Dam Safety
May 2019

**ALBERTA TRANSPORTATION SPRINGBANK OFF-STREAM RESERVOIR PROJECT
RESPONSE TO NRCB AND AEP SUPPLEMENTAL INFORMATION REQUEST 1, JULY 28, 2018**

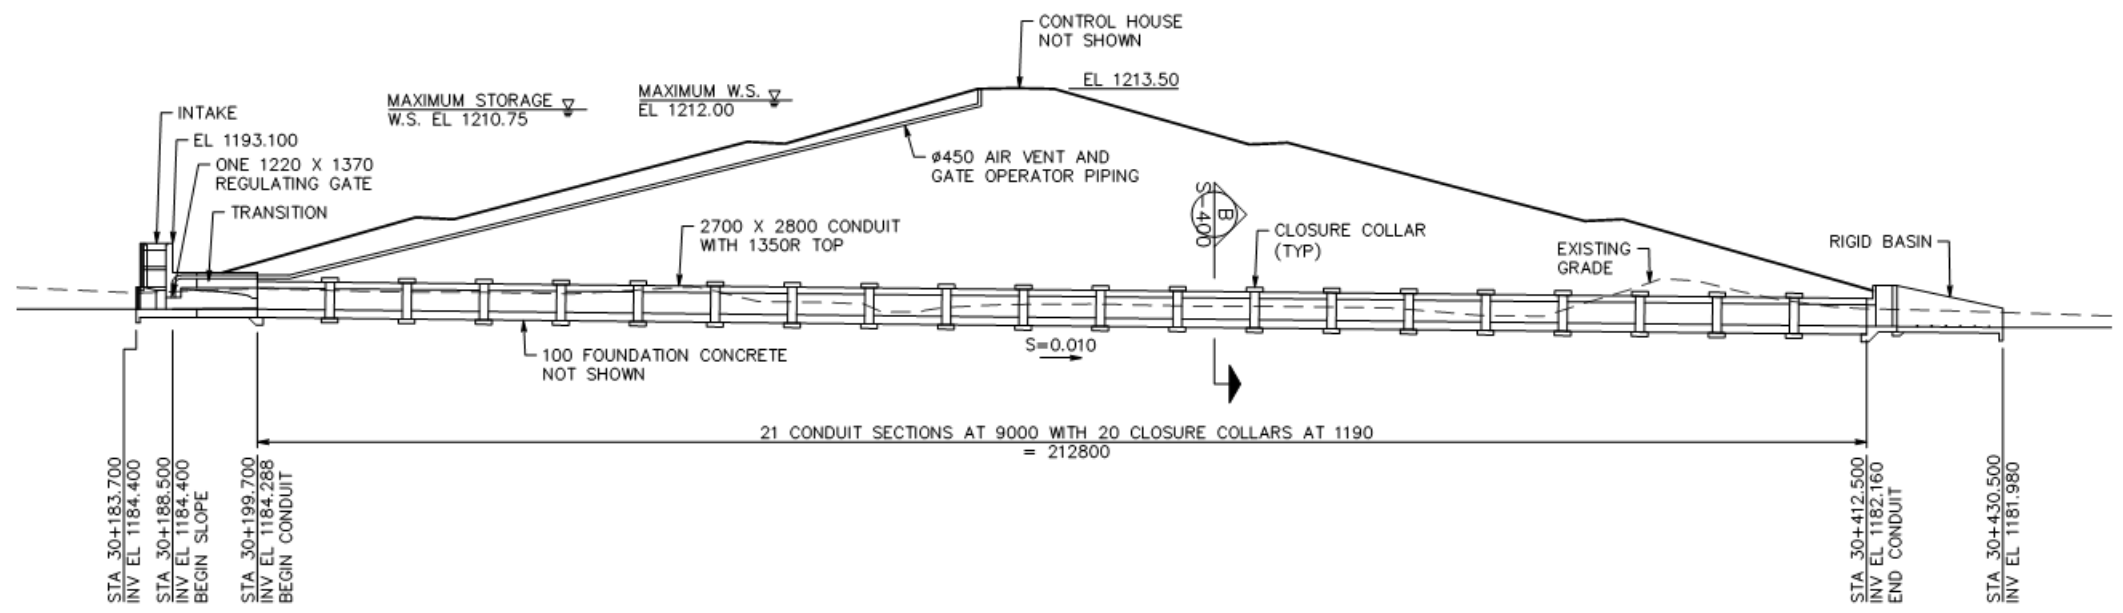
Alberta Transportation states that *The low-level outlet structure (Figure 3-10) consists of an approach channel, discharge gate, gatehouse, discharge conduit and outlet channel. The gate is operated locally by the gatehouse. Figure 3-10 is labeled Low Level Outlet but only shows the basin at the downstream toe. The photo in this figure is a picture of another project with a similar basin but with twin conduits that are round instead of the actual conduit shape for this project.*

- A designed channel will be excavated from the stilling basin to the unnamed creek.
- c. A section through the LLOW is provided in Figure IR475-2.

Permanent and Temporary Features of the Project

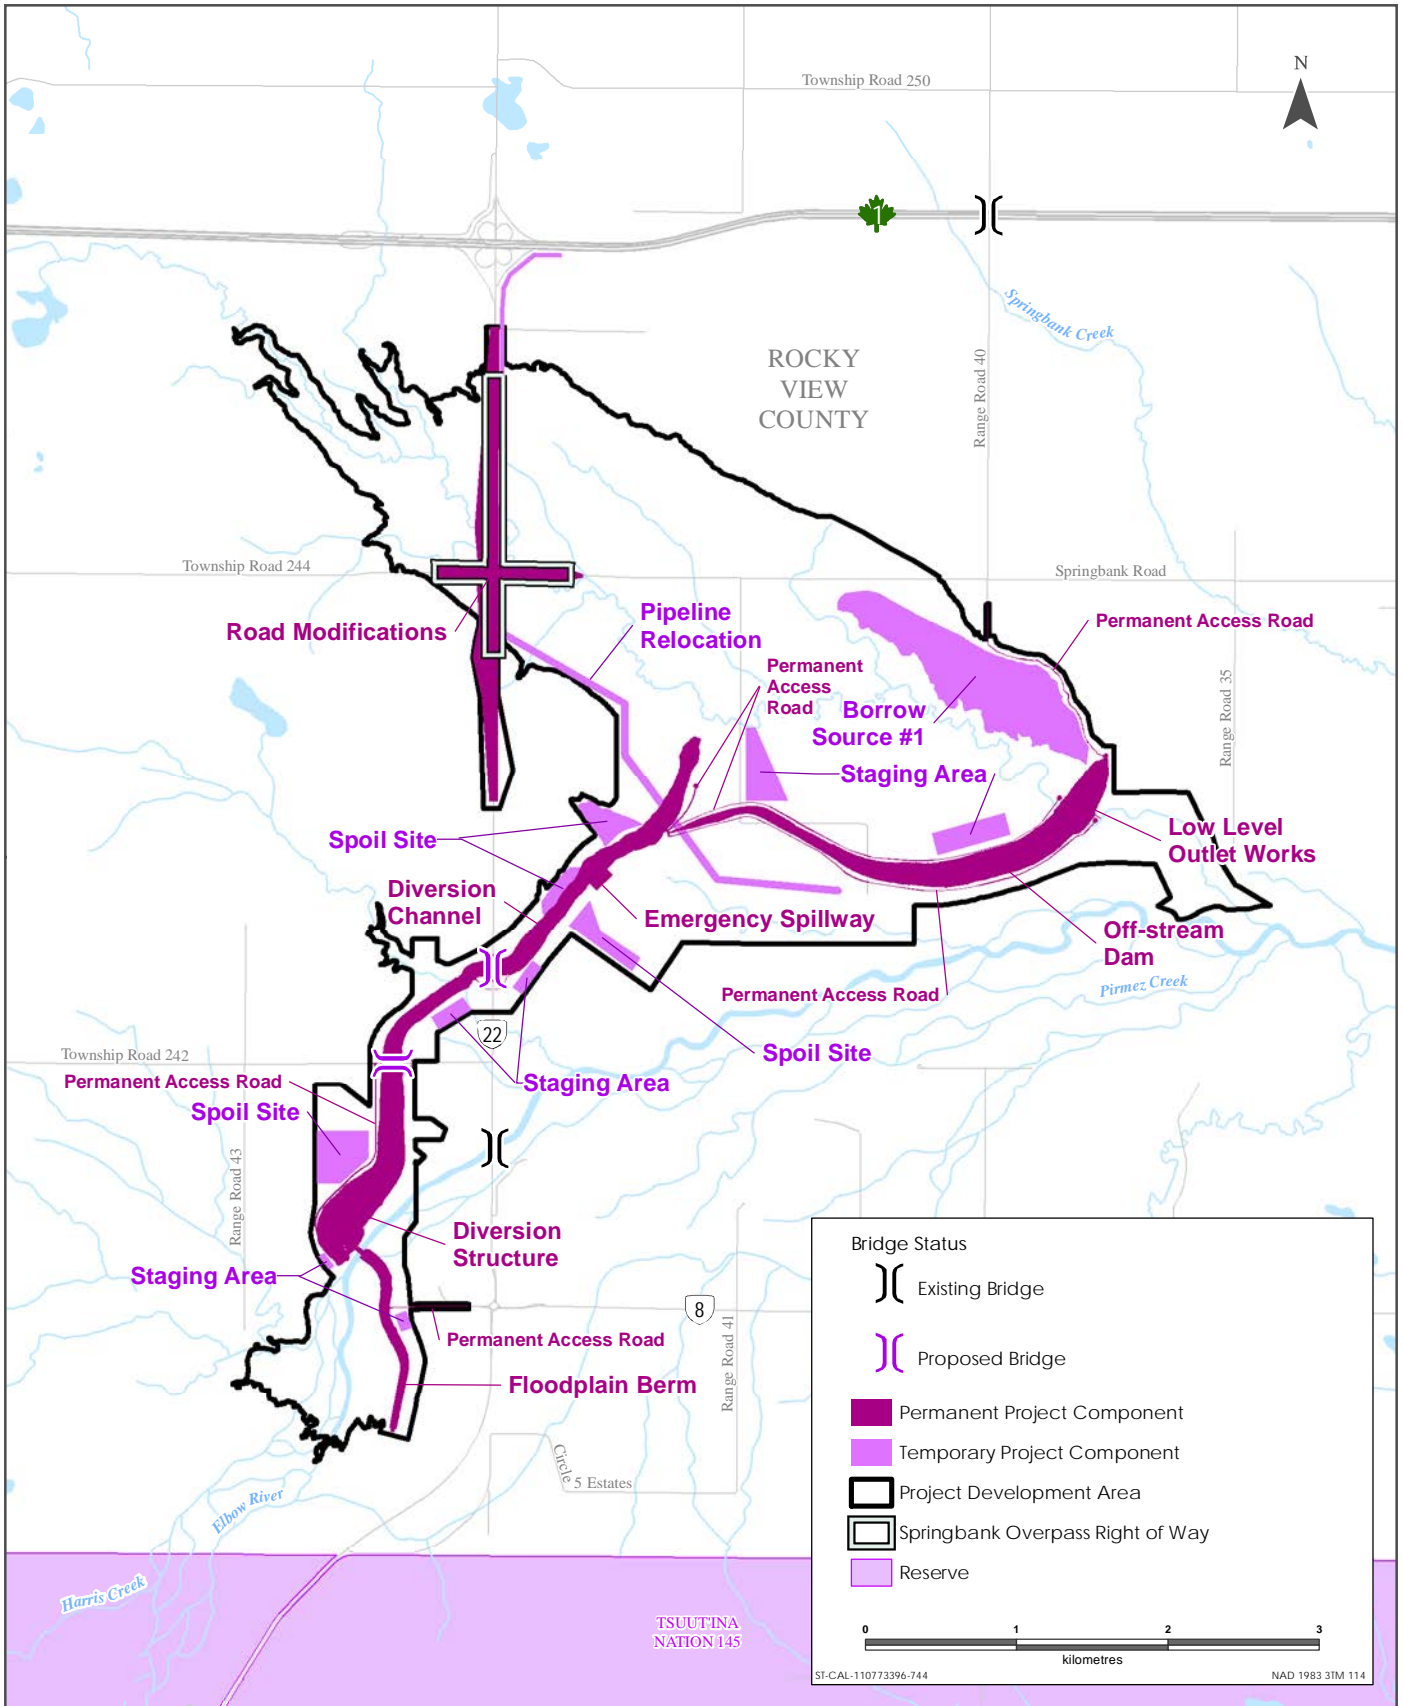
Alberta Transportation states *See Figure 3-1 for the locations of temporary construction laydown areas, which typically include a site trailer, toilet facilities, and areas for parking, fueling, waste and recycling bins, and storage of equipment and materials.* Temporary construction laydown areas are not shown on Figure 3-1.

- a. Provide details for locations of the temporary construction laydown areas. Update the EIA to reflect the proper locations.

- a. The reference to Figure 3-1 is incorrect. The reference should have stated Volume 4, Appendix D, Figure 2-2. Figure IR482-1 (a duplicate of Figure 2-2) illustrates the temporary construction laydown areas (staging areas).

Figure IR495-1 The Diversion System, North End of Floodplain Berm

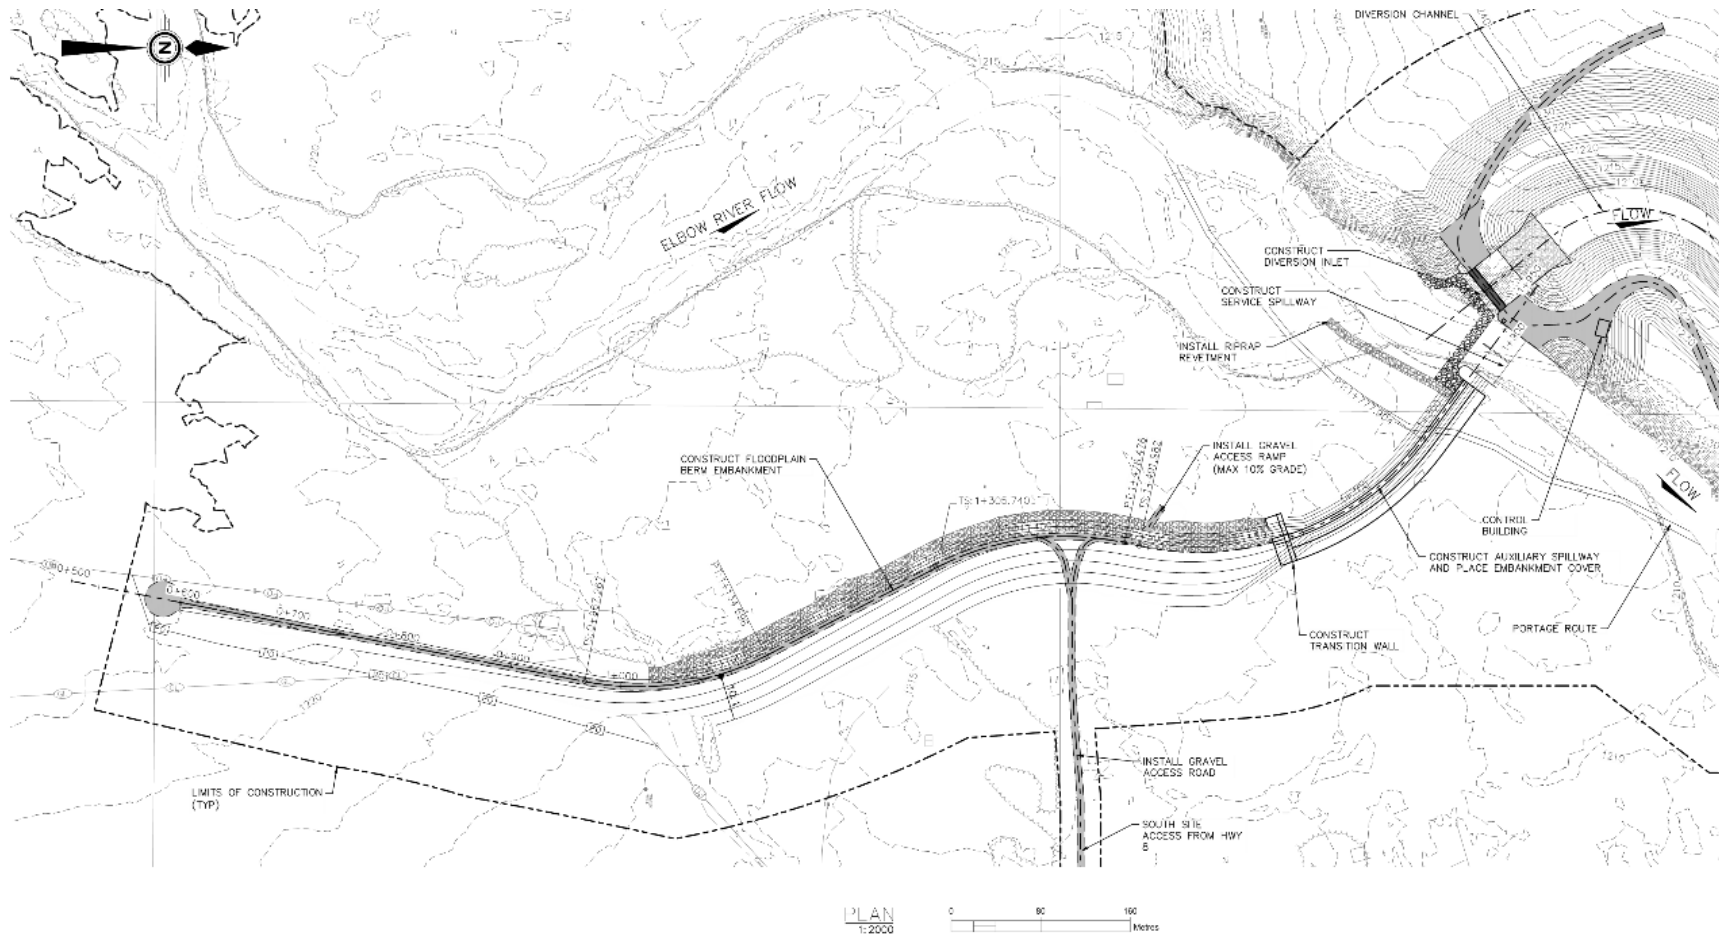
Figure 3-2 shows a floating boom upstream of the diversion structure.

- a. The floating boom has been removed from the design due to safety concerns. No floating booms are currently proposed upstream of the diversion structure. Figure IR495-1 is an update to Volume 1, Figure 3-2, which has the floating boom removed.

Figure IR528-1 Calculated Diversion Structure Hydrographs

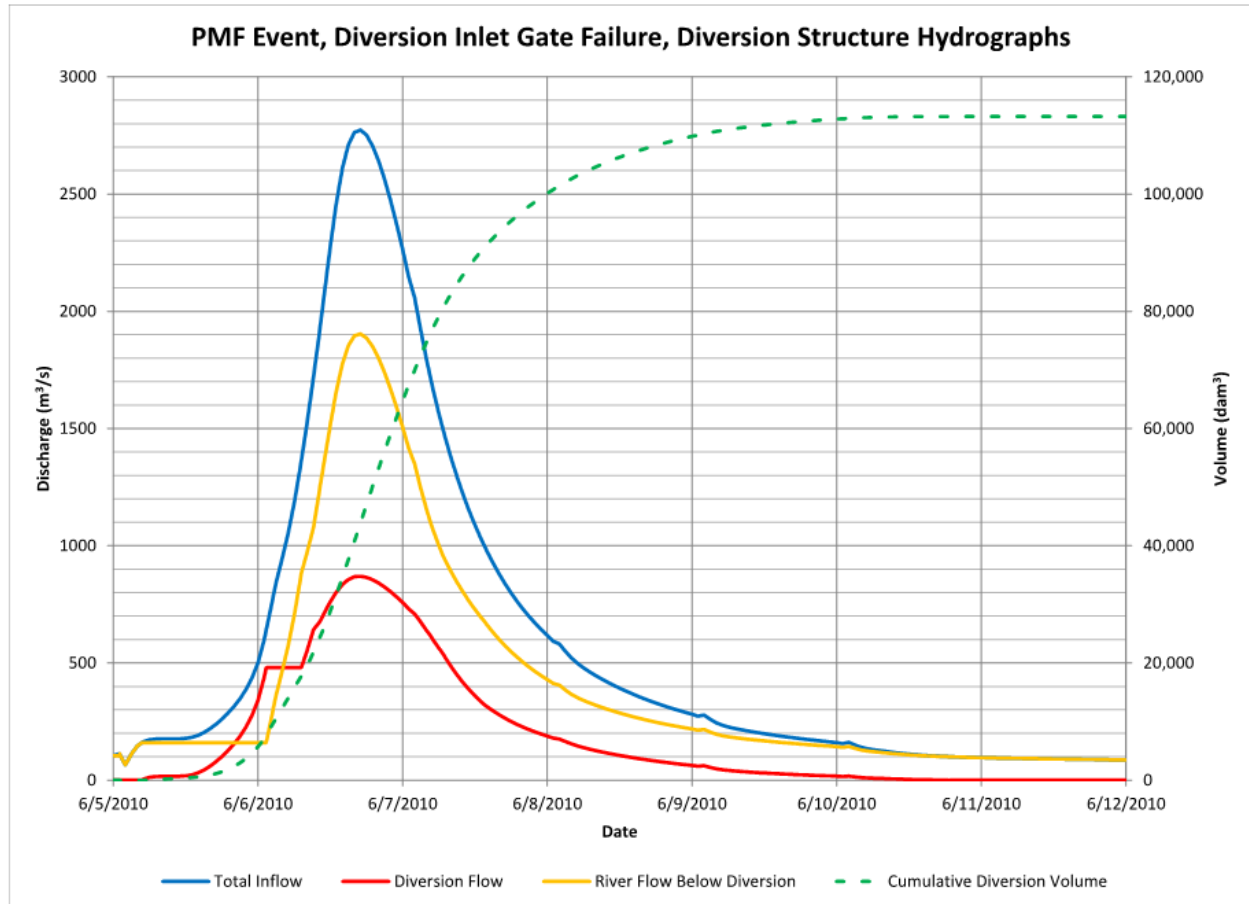
- a. Provide details of the freeboard calculation including routing and wind-wave analysis.
- b. The starting reservoir elevation (on Figure 39) is said to account for sedimentation and local runoff. Does it also account for stored water remaining after passage of the antecedent rainfall event? Explain why or why not. Provide a complete figure showing inflow and outflow hydrographs and reservoir levels throughout the antecedent event and the PMF.

- e. **Why is the reservoir inflow shown on Figure 39 consistently slightly less than the diversion channel inflow even when the emergency spillway is not operating?**

Figure IR528-1 presents the calculated inflow hydrograph.
